PLANT NAME: Turkey Points Units 3 & 4

Amdt. to OL/change to Appendix A tech specs..concerns the effects of fuel rod bowing with attached report entitled "Margins in Turkey Point Units 3, 4 Safety Analysis to Offset the Effects of Fuel Rod Bowing"... Receipts

Re: Turkey Point Units 3 and 4  
 Dockets No. 50-250 and 50-251  
 Proposed Amendment to Facility  
Operating Licenses DPR-31 and DPR-41

Figure 2.1-1. Reactor Core Thermal and Hydraulic Safety Limits, Three Loop Operation

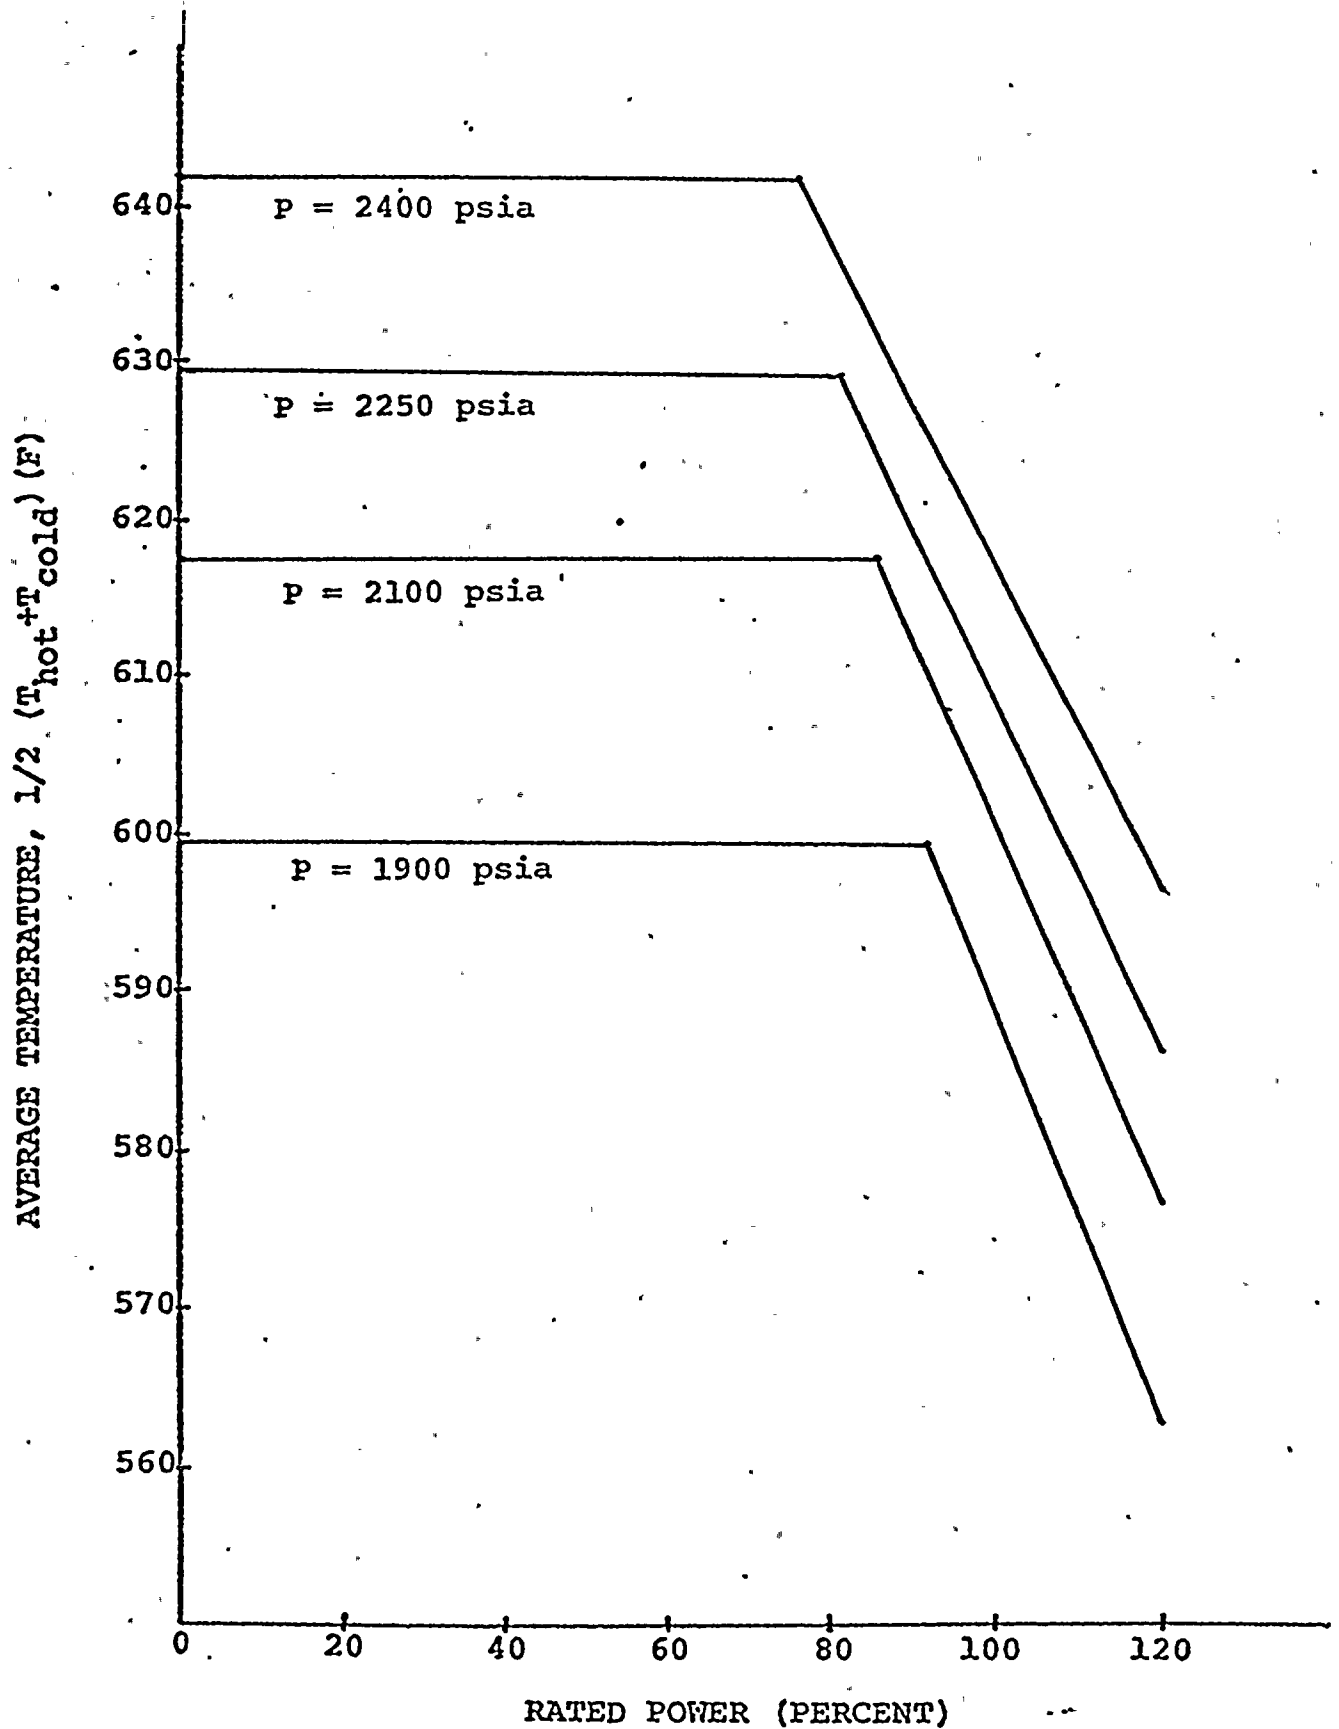
Figure 2.1-1

This is the replacement figure for the thermal and hydraulic safety limits and includes the rod bow penalty.
